ALERT SERVICE BULLETIN

NO. 412-09-135
DATE Aug 25, 2009
PAGE 1 of 16

MODEL AFFECTED: 412 /412EP

SUBJECT: HIGH AFT CROSTUBE ASSEMBLIES P/N 412-050-011-101, / -103, / -105, / -107, 412-050-045-105: MANDATORY INSPECTION

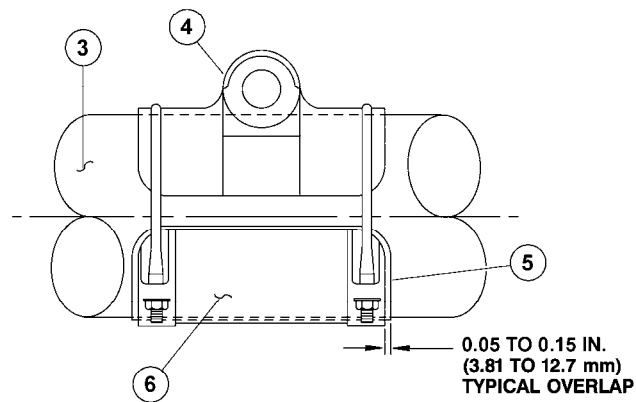
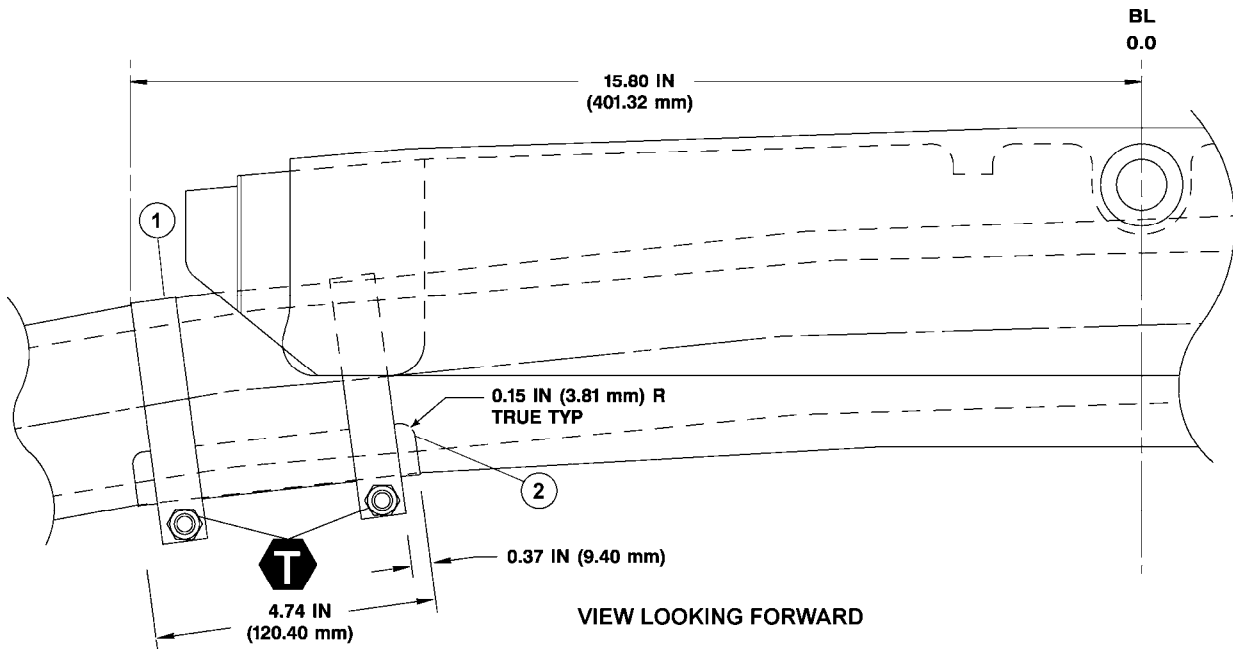
Helicopter towing operations can result in fatigue damage to the aft crosstube. To prevent this damage, the recommendation to restrain the high aft crosstube as stated in the maintenance manual (BHT-412-MM-2), is **now mandatory** when towing at weights greater than or equal to 8900 lb.

The puller assembly used in the Service Instruction BHT-412-SI-58 is equipped with a load limiter called a "Load Sentry". The mechanism is preset to provide a 4000 pound tension load on the crosstube. This high load counteracts the loads being applied to the crosstube by the towing actions and weight of the helicopter. The Load Sentry is contained in the handle of the retention device and works similar to a torque wrench.

1. Install CAUTION decal P/N 212-070-600-143 per Figure 3 on pilot and co-pilot side and apply sealer (C-349) allowing 0.125 in (3.175) overlap on all sides of decal, as required.
2. Review Bell Helicopter Service Instruction BHT-412-SI-58 to determine the items required to use of this kit.

FIGURE 1

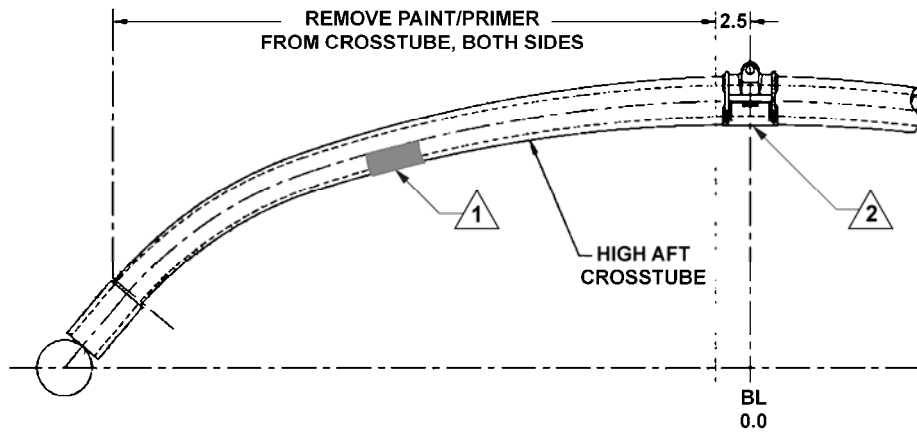
2. Remove the aft crosstube from the landing gear assembly.
3. Remove the support beam from the aft crosstube as per BHT-412-MM
4. Remove the hardware retaining BL 14 clamp assemblies P/N 412-050-045-115 or / -117 (left & right hand) on the high aft crosstube. Refer to Figure 1 below.

5. Use heat gun to soften sealant bonding the clamp assembly to the crosstube. Separate the clamp from crosstube and the abrasion strip (if installed).

1. Clamp assembly (412-050-045-115/-117)
2. Abrasion strip (206-050-301-111)
3. Aft crosstube (Ref)
4. Upper center support (412-050-006-101)
5. Larson L101 abrasion strip (raw material size 0.020 x 5.0 x 6.0 inch (0.051 x 127 x 152.4 mm))
6. Lower center support (412-050-007-101) replaced by (604-026-003)

T 50 TO 70 IN-LBS
(67.8 TO 94.9 Nm)

FIGURE 2

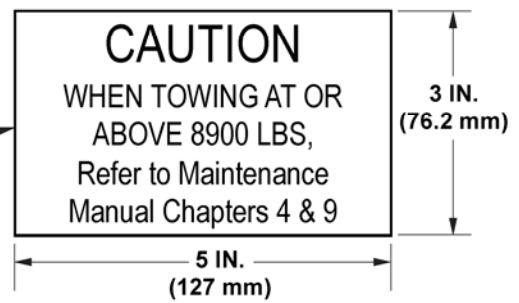
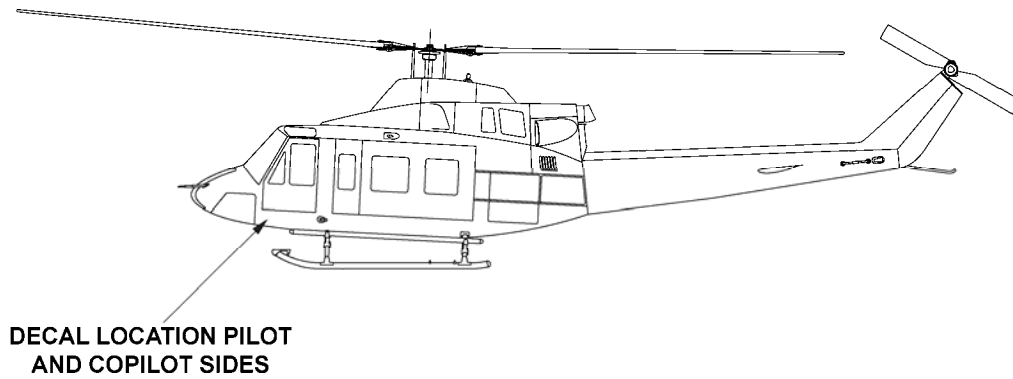
2. Prepare crosstube for the inspection process by removing the paint on the crosstube in the area indicated in Figure 2.
 - a. Crosstube P/N 412-050-045 will require the paint to be removed in area depicted in Figure 2 with the exceptions of the abrasion strip areas and the 412-050-006-101 upper and 412-050-007-101 lower supports (BL 0.0). The paint and Larson abrasion strip will need to be removed in the lower support area at BL 00 if support P/N 604-026-003 has been installed.
 - b. Crosstube P/N 412-050-011-ALL which does not have the abrasion strip under the clamp assembly at BL 14 or Larson L101 material under the lower support at BL.0.0 will require the paint to be removed under the lower center support.
3. Apply chemical paint remover (C-436) to the crosstube with a brush following manufacturer's directions and the BHT-ALL-SPM.

- 1 Protect abrasion strip P/N 206-050-301-111 (if installed) during paint removal process.
- 2 Protect upper and lower support during paint removal process. Crosstubes 412-050-011 in original condition without larsen L101 under the lower support will require the lower support to be removed for paint stripping and fluorescent penetrant inspection.
